HISTORIC AND DESIGN REVIEW COMMISSION

October 16, 2024

HDRC CASE NO: 2024-355
ADDRESS: 1223 VIRGINIA BLVD
LEGAL DESCRIPTION: NCB 3886 BLK 2 LOT 18
ZONING: RM-4, H
CITY COUNCIL DIST.: 2
DISTRICT: Knob Hill Historic District
APPLICANT: SHAUN CANE/GREATEST NATION EQUITY LLC
OWNER: SHAUN CANE/GREATEST NATION EQUITY LLC
TYPE OF WORK: Fenestration modifications
APPLICATION RECEIVED: September 27, 2024
60-DAY REVIEW: November 26, 2024
CASE MANAGER: Bryan Morales

The applicant is requesting a Certificate of Appropriateness for approval to remove four existing non-conforming windows on the structure's east side and install three salvaged wood windows to match the existing wood windows onsite.

RIGHT SIDE (Facing house from street)

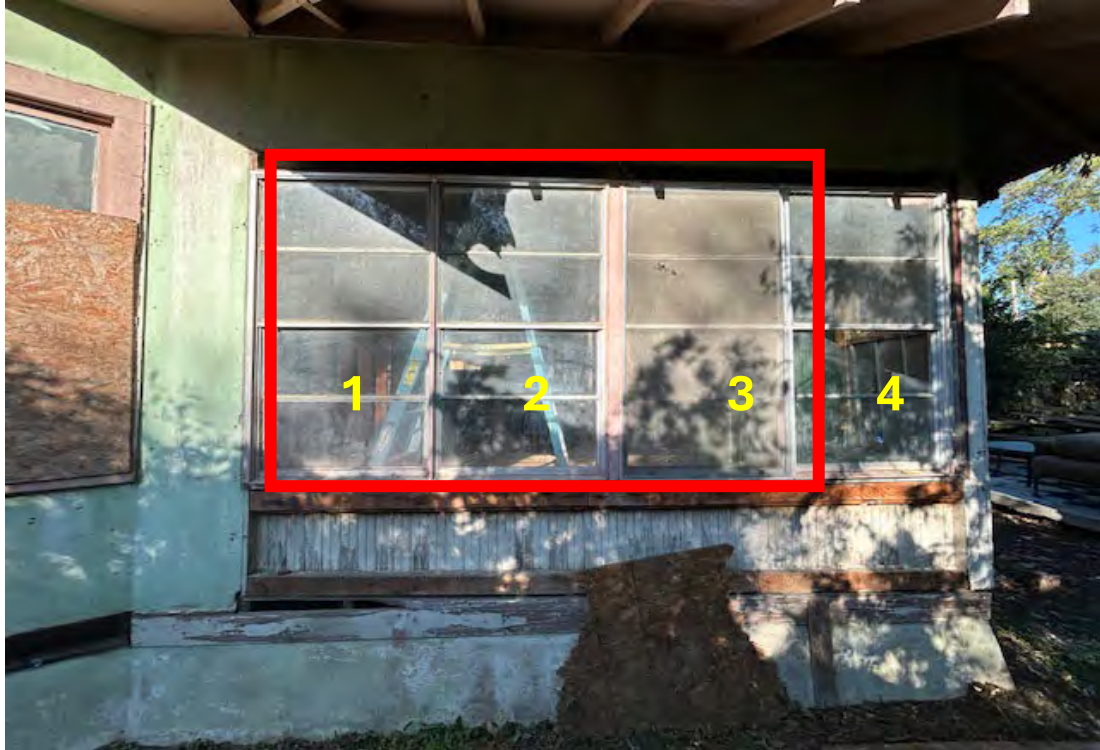
- rear window section IS NOT original to house
- current windows are not wood or historic in design or material.

-**REQUEST:** replace with 3 Salvaged wood windows (see sketch with dimensions). Use same elevation as existing wood windows on east and west side of house.

ELEVATION EAST SIDE

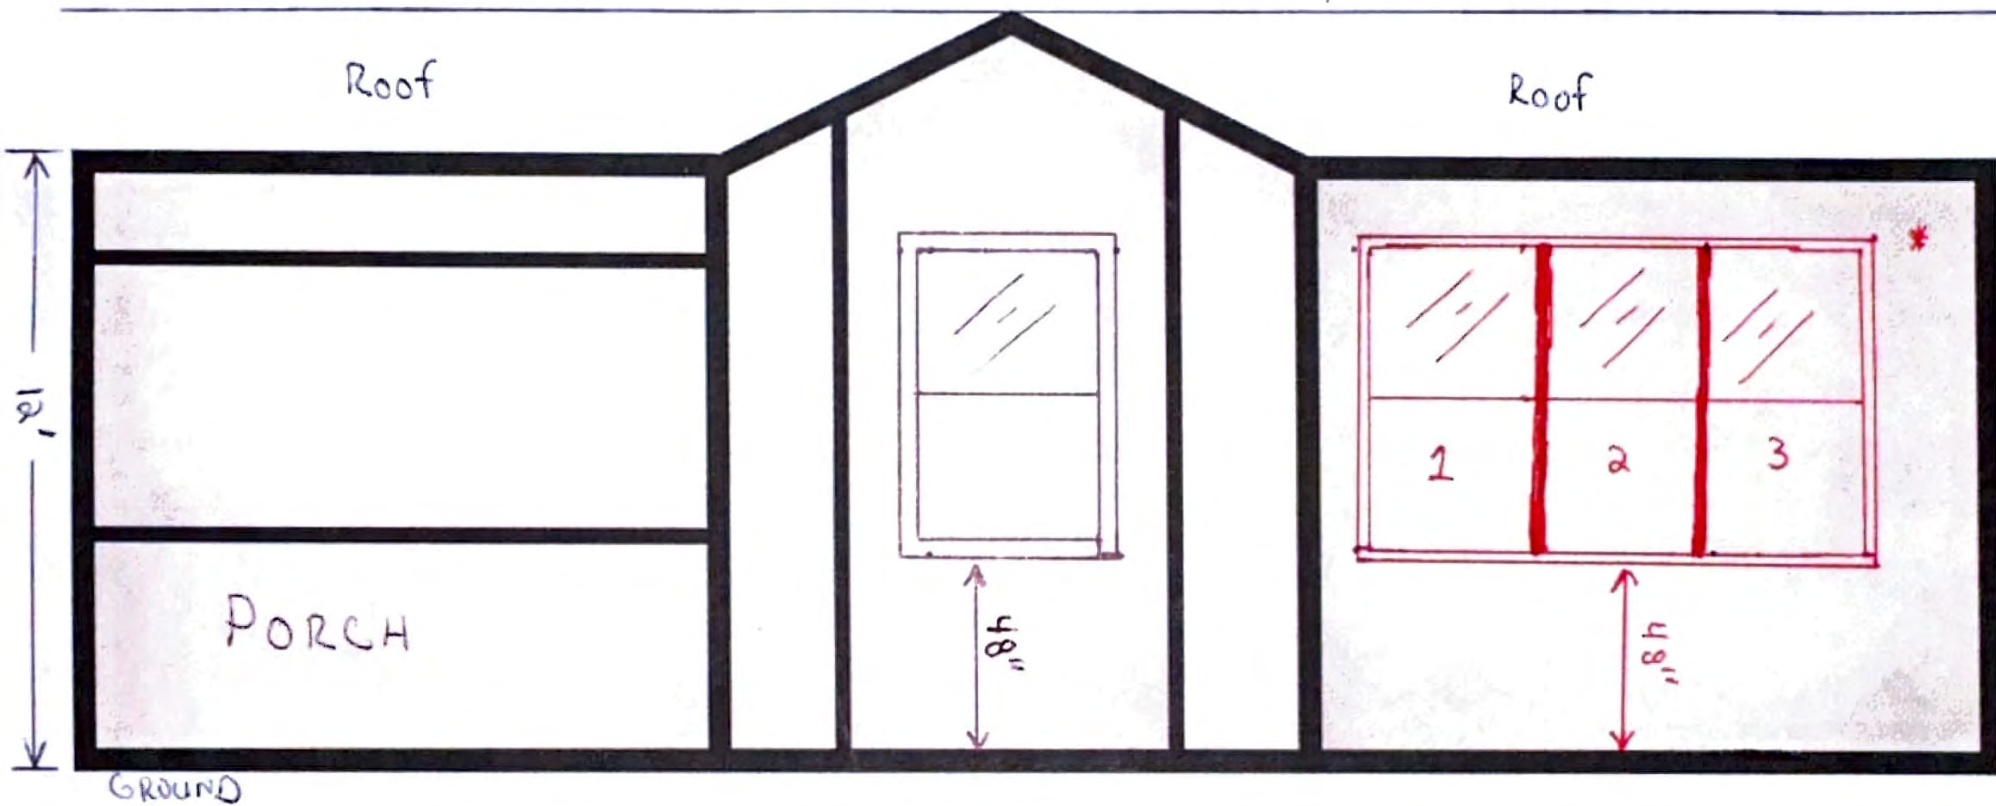
* Replace current Aluminum windows with 3 salvaged WOOD WINDOWS consistent in size and likeness of the other WOOD WINDOWS IN THIS HOUSE (see "WOOD WINDOW" sketch for specs)

\$\$ - Repair Stucco throughout exterior, which is existing.
